**The Meadows at Bailey Canyon Specific Plan
Environmental Impact Report**

FEBRUARY 2022

Responses to Comment Letters Received on the Draft EIR

Map from the Specific plan

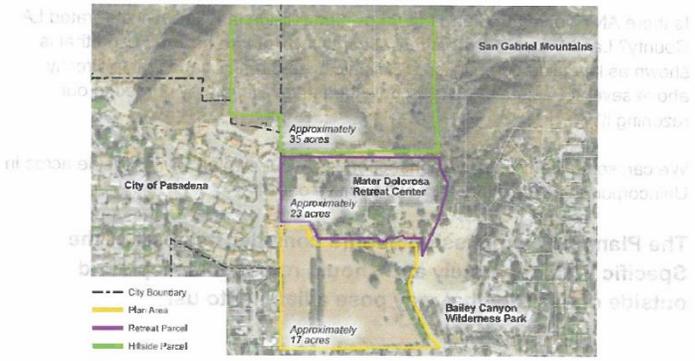
The 2 remaining parcels which they are now able to donate include
APN: 5761-001-001 in Sierra Madre - 20 acres, designated Hillside Zone AND
APN: 5760-027-013 in Unincorporated LA County - 16.74 acres zoned residential
Maps are attached showing those parcels.

Is there ANY benefit to Sierra Madre owning Hillside land in Unincorporated LA County? Land that is in the highest severity level of Fire hazard? Land that is shown as landslide potential on a Seismic hazard map? Land that is directly above several Pasadena housing developments? Have they agreed to our rezoning it??

We can see a lot of negative consequences in our owning 16.74 Hillside acres in Unincorporated LA County - but NO positive ones!!

The Planning Commission should consider this part of the Specific Plan separately and should refuse to accept land outside of our City that may pose a liability to us!

- I2-11** The comment provides background information associated with the open space hillside conservation easement area and information contained in the Specific Plan and does not raise an issue related to the adequacy of any specific section or analysis of the Draft EIR. It should be noted that Figure 1-2, Vicinity Map, from the Specific Plan has been revised for clarification, in order to show the most recent boundaries of the proposed 35-acre open space hillside conservation easement area. No further response is required or provided.

DEIR - PROJECT OBJECTIVES

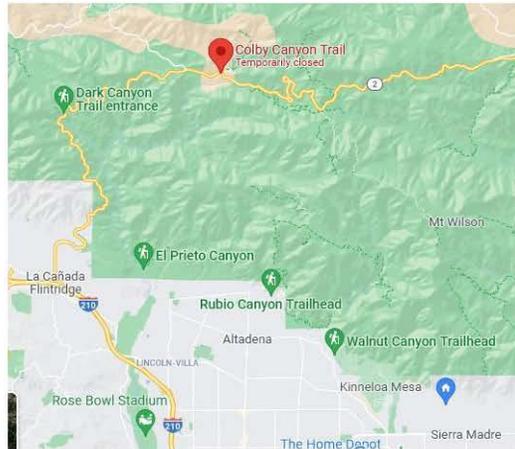
5. Preserve the hillside open space area by dedicating approximately 30 acres north of the Mater Dolorosa Retreat Center to the City, in order to preserve a portion of Colby Canyon and the Colby Canyon Trail, which would be used by wildlife for movement up and down slope; preserve native vegetation communities and drainages; and preserve land adjacent to the Colby Canyon stream.

Open space has been defined and included as Figure 3-4 of the EIR. In addition, the discussion about the open space dedication has been removed from the alternatives discussion.

Figure 2
Trip Distribution

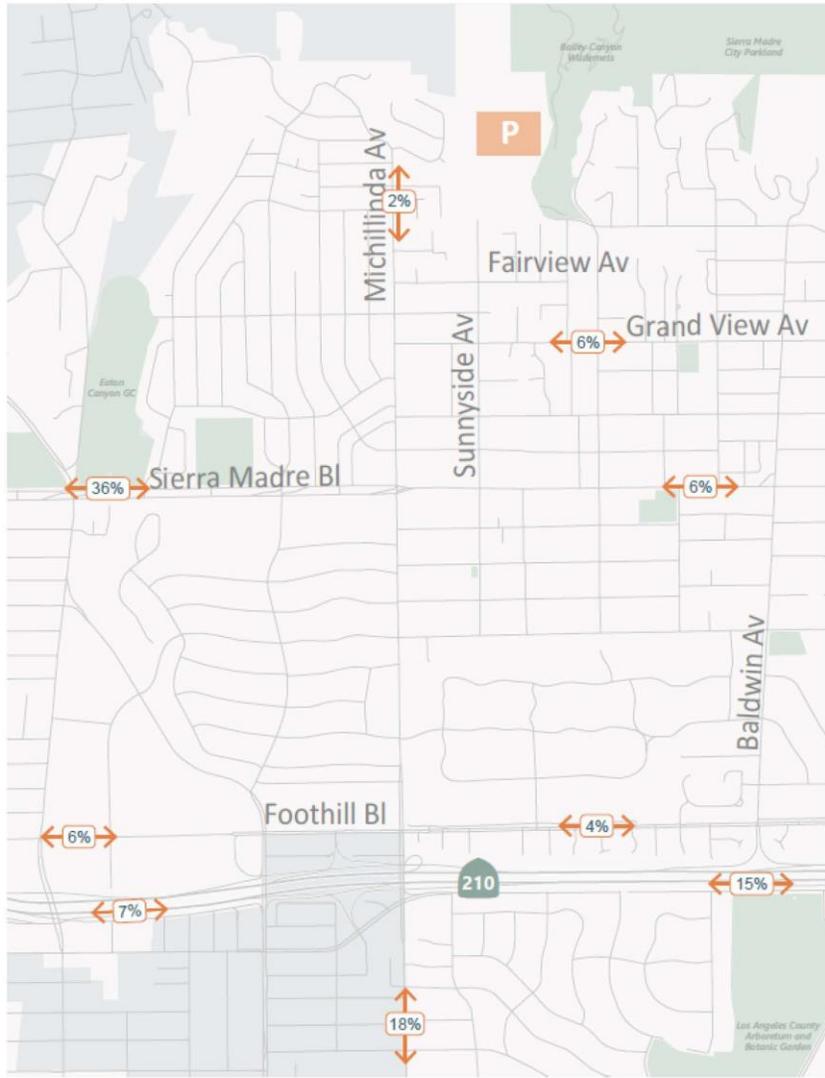
The Project trip distribution reflects the spatial distribution of trips traveling to and from the Project site. To determine where Project trips will travel, we applied a "select zone analysis" using the Southern California Association of Governments (SCAG) travel demand model. This method predicts where trips travel to/from for the area immediately surrounding the Project. The estimated trip distribution of the Project trips is shown on **Figure 2**.

Figure 3
Peak Hour Traffic Volumes and Lane Configurations
Build-out (2025) With Project Condition

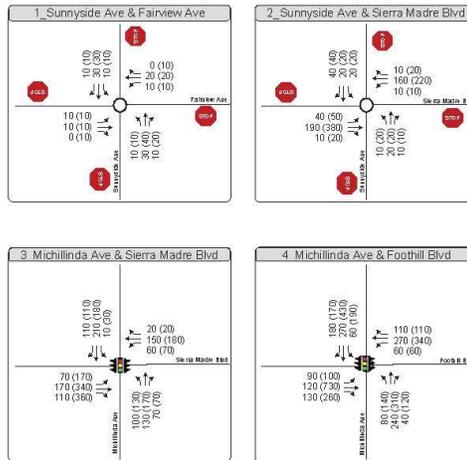
We added the Project trips to the study segments and intersections following the trip distribution identified above. The following **Table 6-1** and **Table 6-2** present the level of change expected on the study roadways as a consequence of the Project. The peak hour intersection traffic of Build-out (2025) with Project condition is shown in **Figure 3**.

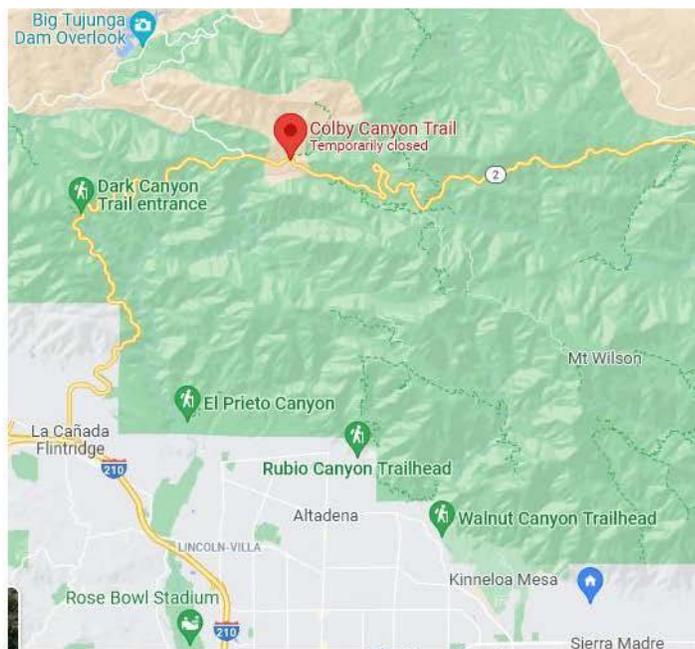
The project description states that it would include “approximately 3.39 acres of open space (including 3.04-acre dedicated neighborhood park) and identifies “open space dedication as a community benefit.”

If 3.04 acres of the 3.39 acres is the park, then that leaves .35 acres of open space. Under Project Location above, the area is identified as 35 acres. In project objective number 5, 30 acres is referenced and the area is clearly misidentified as being near Colby Canyon and Colby Canyon Trail. (see Objective 5. Preserve the hillside open space area by dedicating approximately 30 acres north of the Mater Dolorosa Retreat Center to the City, in order to preserve a portion of Colby Canyon and the Colby Canyon Trail, which would be used by wildlife for movement up and down slope; preserve native vegetation communities and drainages; and preserve land adjacent to the Colby Canyon stream). Colby Canyon is above the city of La Canada nowhere near this project. See map below. Thus, the location, boundaries, and acreage of the “open space” are not clear.

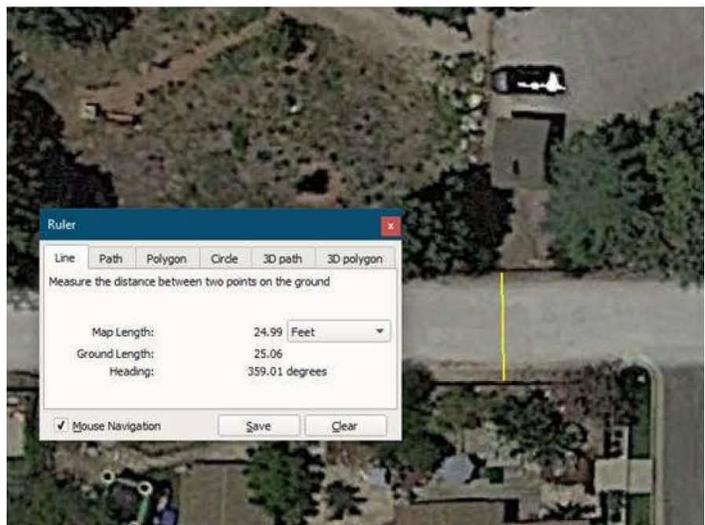
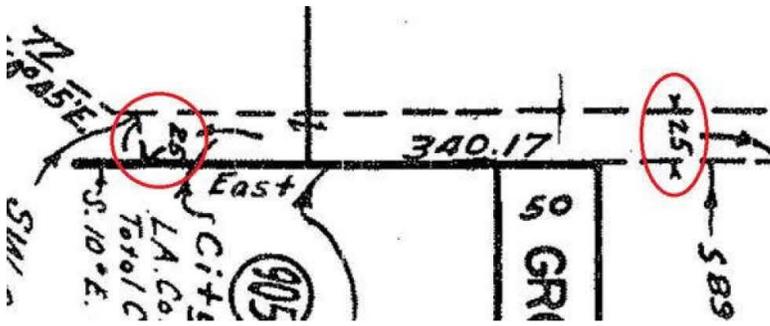
Vincent, there is an inconsistency between the Meadows draft EIR and the Specific Plan.

The right-of-way section of Carter that the city owns south of Bailey Canyon Park is listed as being 20' wide in the Specific Plan (page 20) and 25' wide in the dEIR.
